Kenavon Drive, Reading

Proposed Amendments

West Block and Middle Block Stage 4 Amendments, September 2021

West Block Proposed Amendments Drawing Comparison

Proposed Elevations

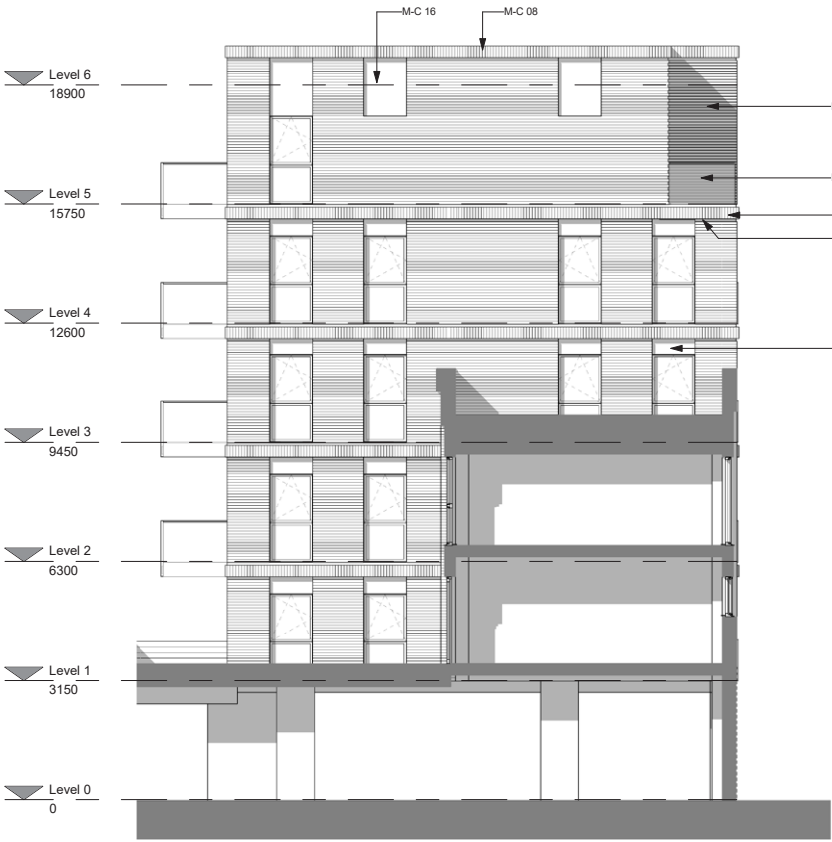
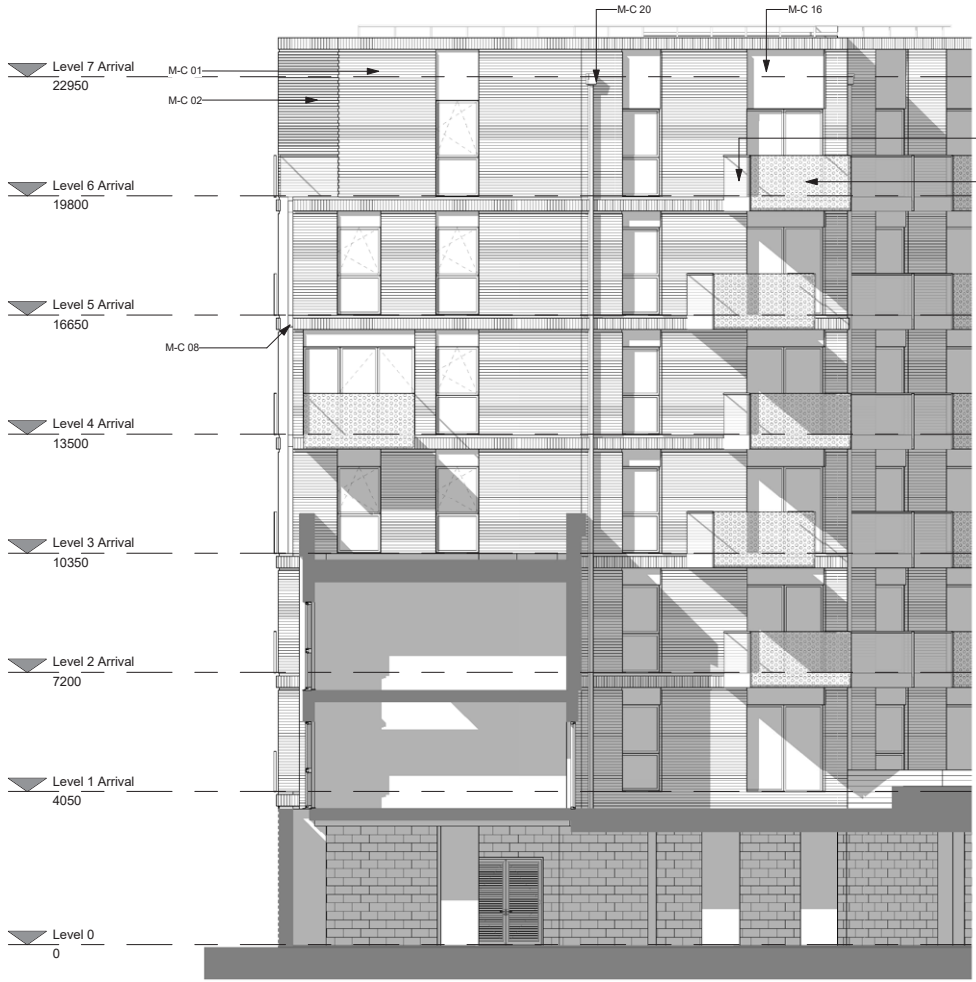
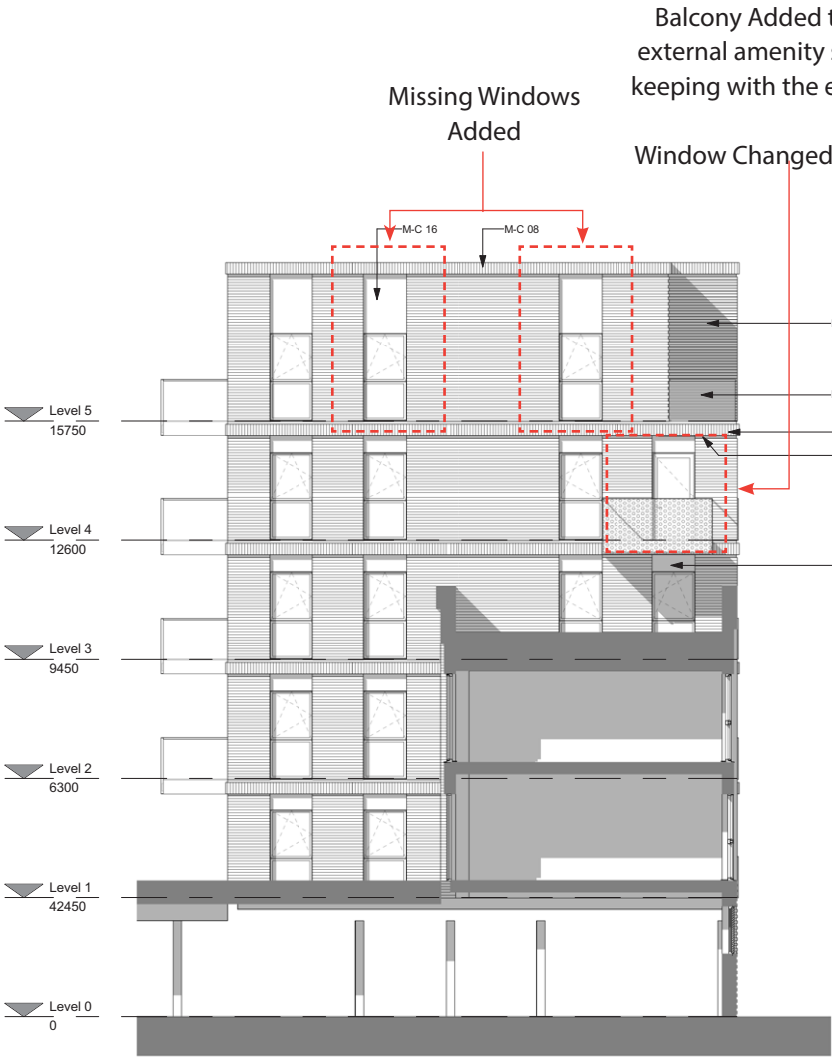
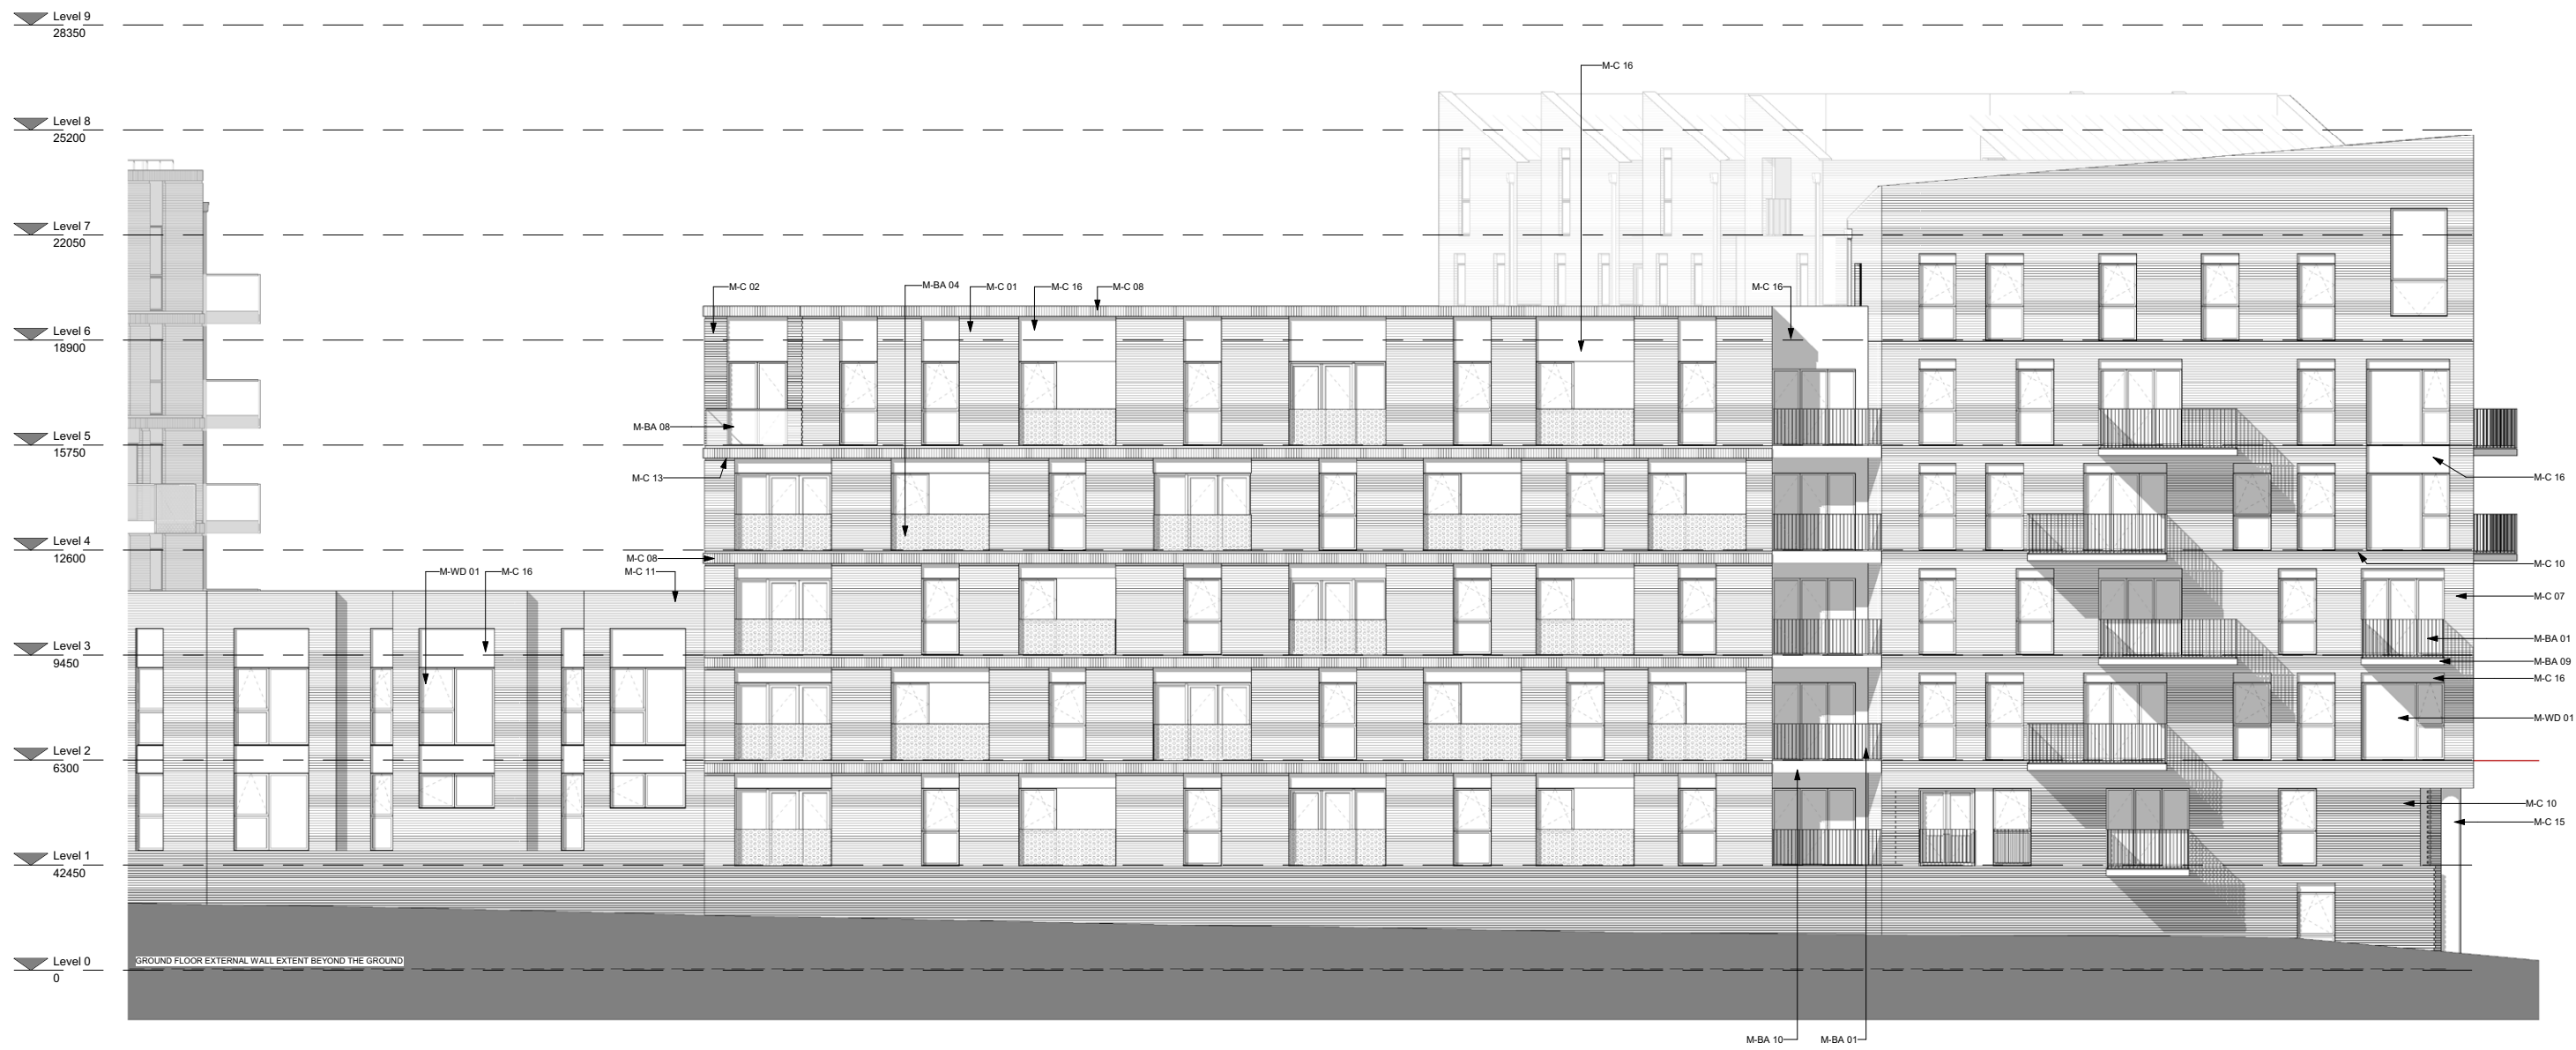
Balcony Added to give external amenity space in keeping with the elevation

Window Changed to Triple Window with Sliding Doors

Balcony Added to give external amenity space in keeping with the elevation

Window Changed to Door

Missing Windows Added

Section showing high-level ventilation louvres on West Elevation facing Forbury Road

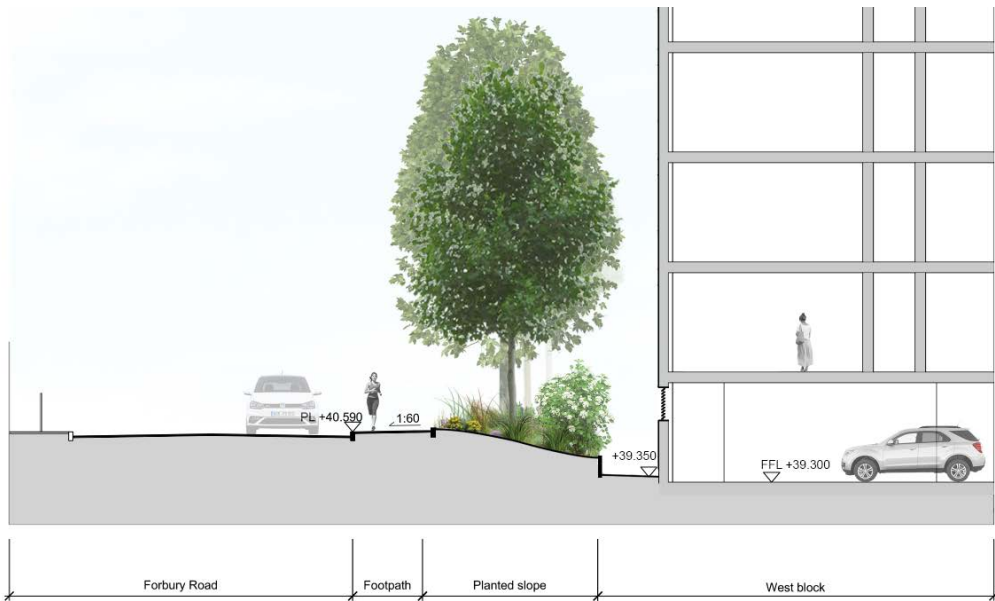
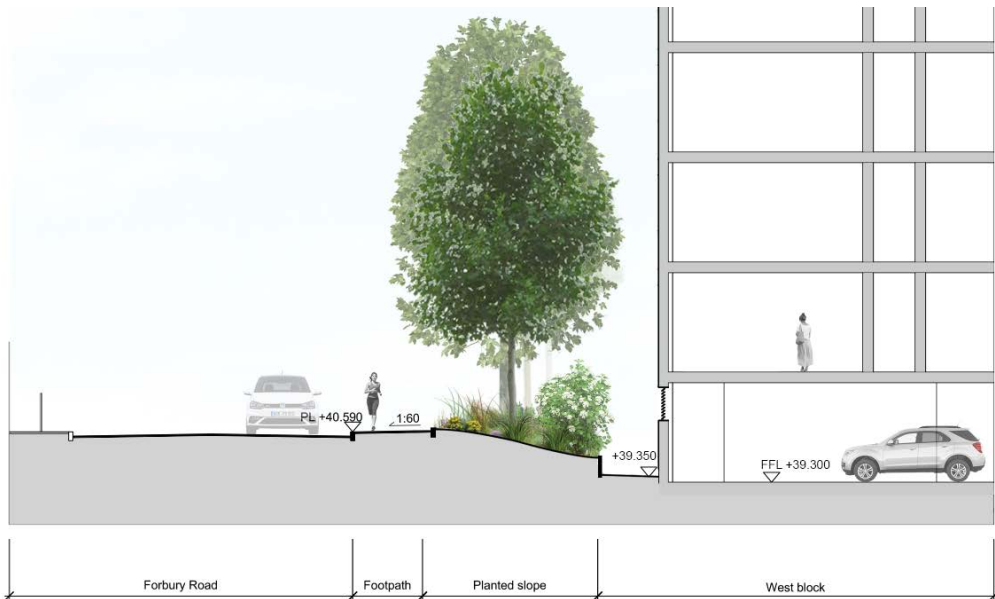
Juliette Door and Panel swapped to allow more space for kitchen countertop run.

High-level ventilation louvres added to the West Elevation to support the "mixed ventilation" system using a combination of exterior openings, a mechanical extract system and impulse fans.

Balcony Added to give external amenity space in keeping with the elevation

High-level ventilation louvres added to the West Elevation to support the "mixed ventilation" system using a combination of exterior openings, a mechanical extract system and impulse fans.
